# City of Hutto

### **Planning and Zoning Commission Tuesday, November 7, 2023 at 7:00 PM Council Chambers**

**To:** Planning and Zoning Commission  
**Subject:** Consideration and possible action to disapprove the proposed Elm Park Townhomes Preliminary Plat, 12.043 acres, more or less, of land, proposing one residential lot, located along Elm Park Street in the Star Ranch MUD (ETJ).  
**Meeting:** Tuesday, November 7, 2023  
**Department:** Development Services  
**Staff Contact:** Ashley Bailey

**To:** Planning and Zoning Commission  
**Subject:** Consideration and possible action to disapprove the proposed Hippo Partner - LI Hutto Megasite Preliminary Plat, 52.57 acres, more or less, of land, located north of County Road 132 and west of FM3349.  
**Meeting:** Tuesday, November 7, 2023  
**Department:** Development Services  
**Staff Contact:** Ashley Bailey

**HIPPO PARTNERS - LI HUTTO MEGASITE**  
CITY OF HUTTO, TEXAS  
**PRELIMINARY PLAN AND DIMENSIONAL CONTROL**

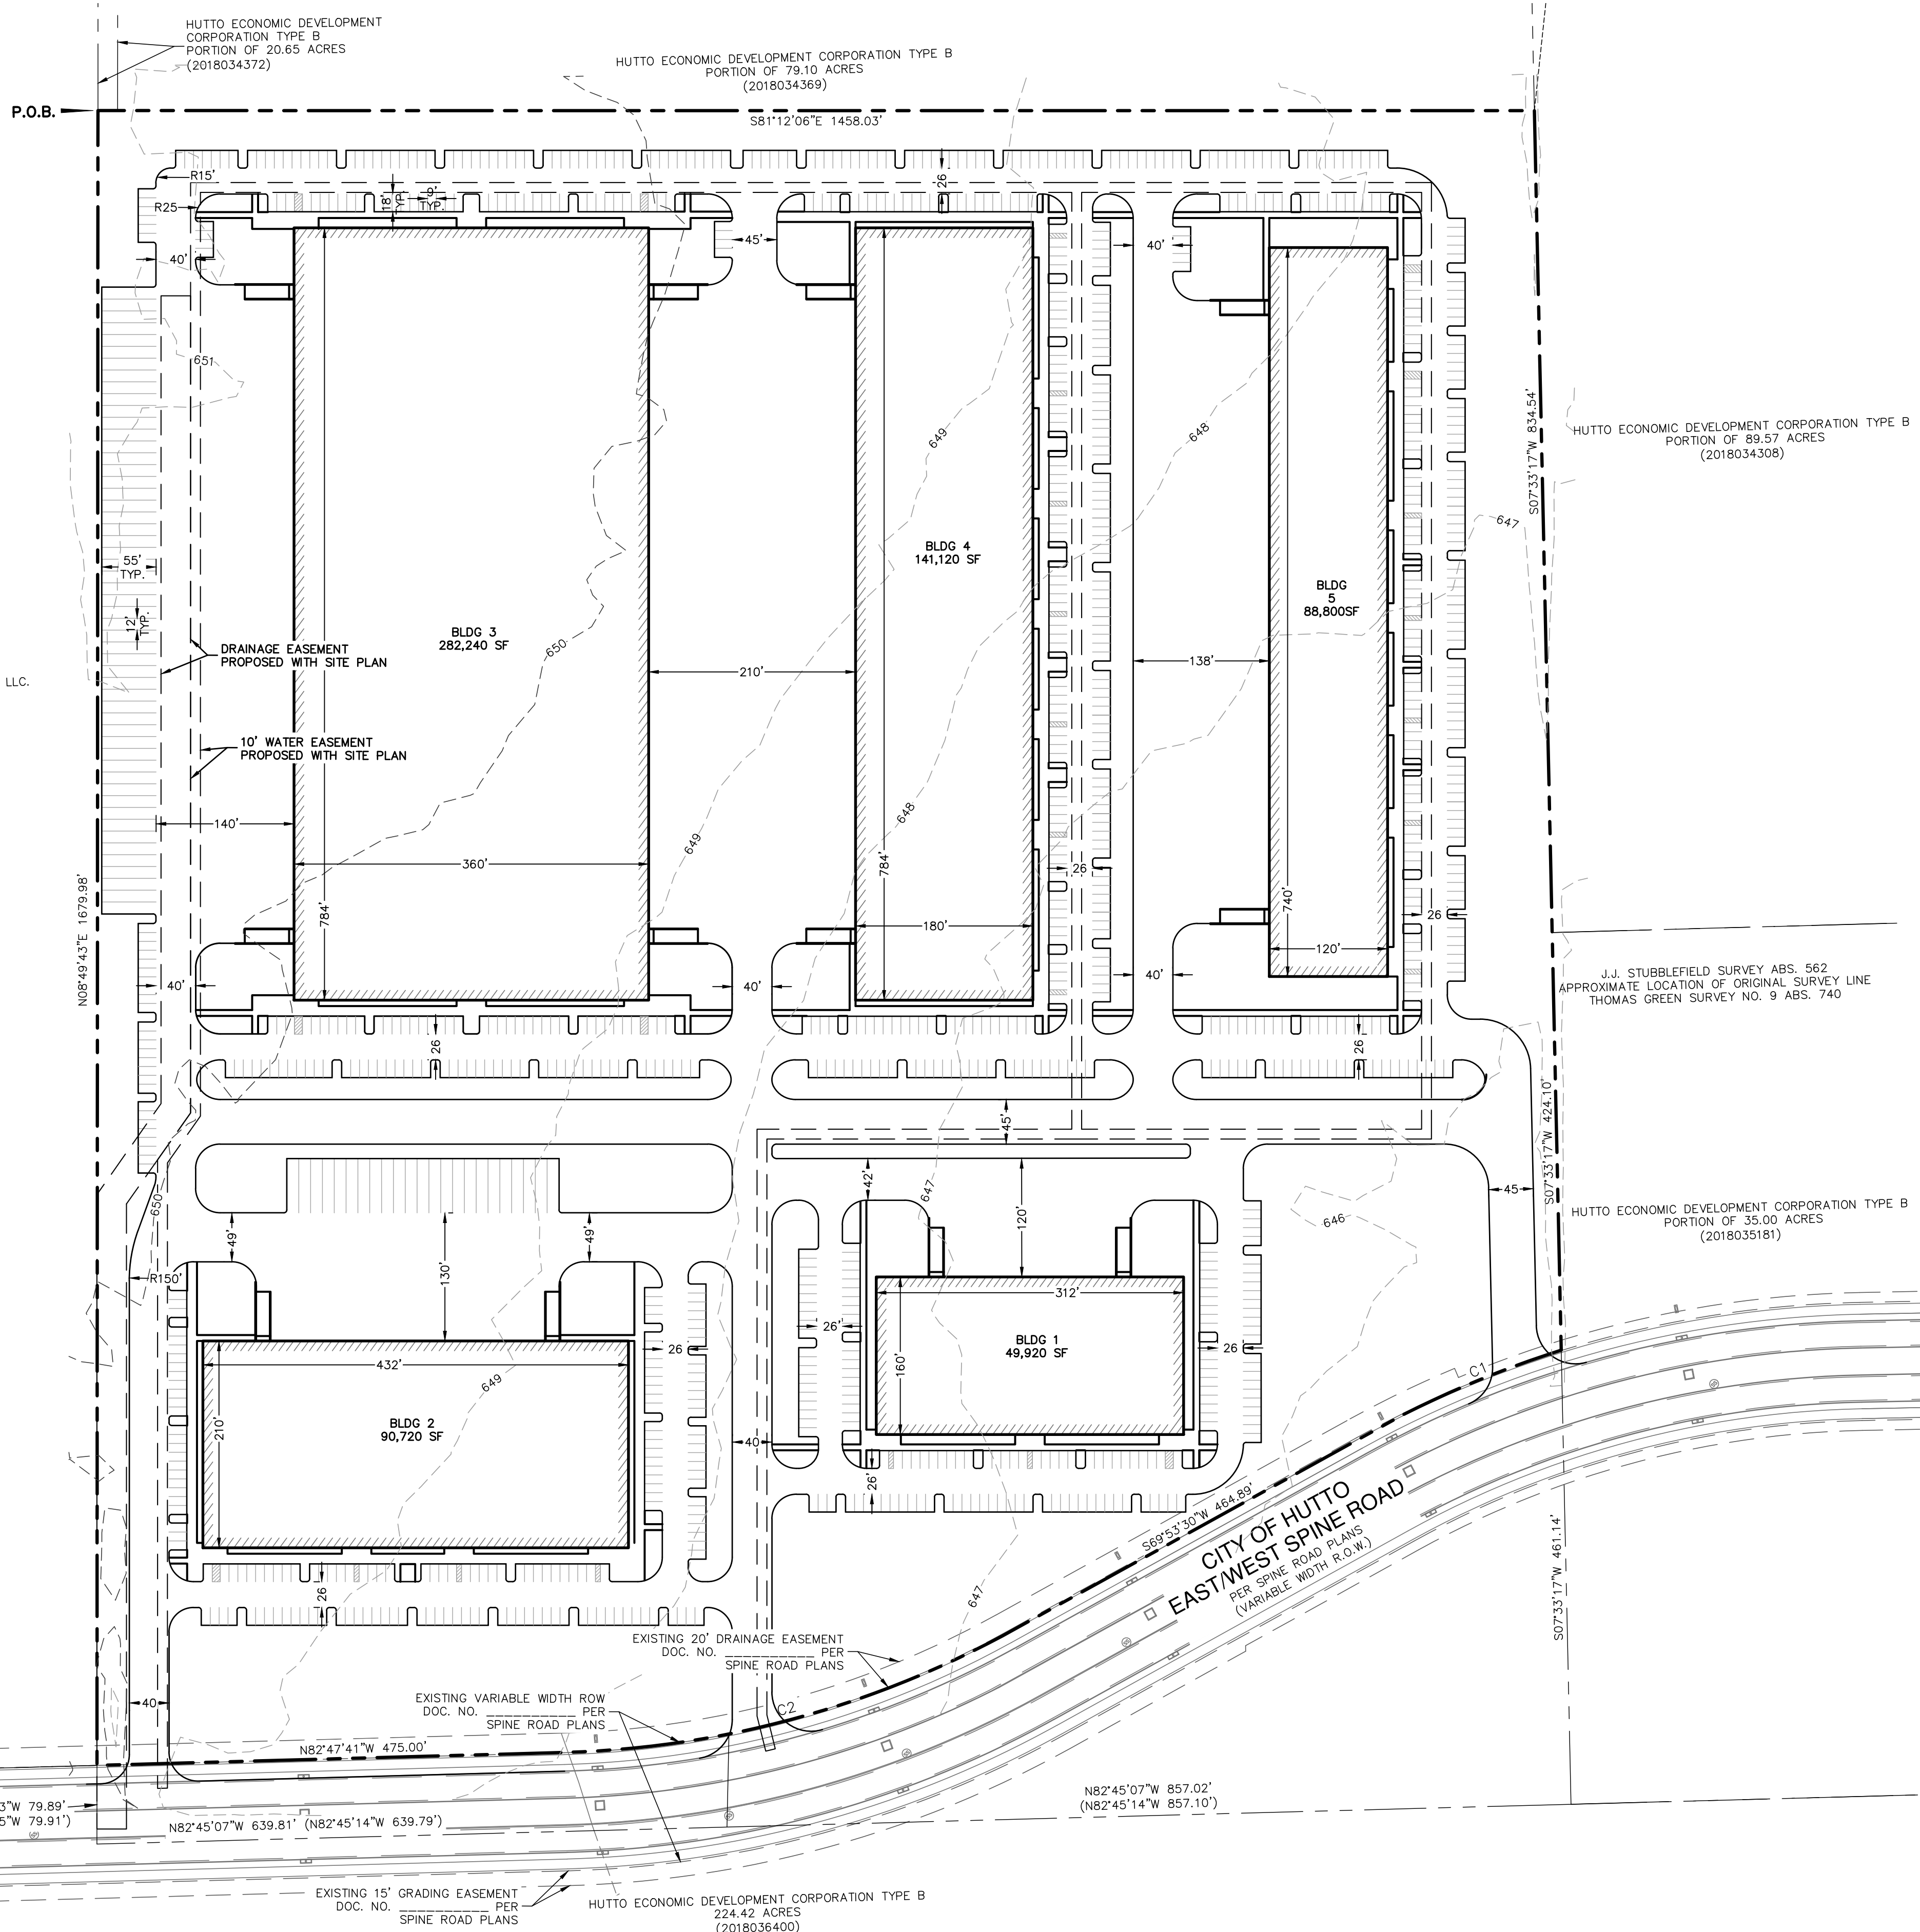
typically these are separated and not combined in to a single set for a preliminary plat. Usually it would be a survey sheet, a preliminary plat, and utility schematics. please revise.

Remove site plan features from the Preliminary Plat schematic.  
Provide copies of all easements per the application.  
Add lot/block and phasing if proposed  
Add a title to the top of the schematic  
Add basic information from the checklist as provided in the application - missing acreage, lots by type, ROW, total number of lots/blocks.  
Cannot review for content with the content checklist is not followed - revise and resubmit.
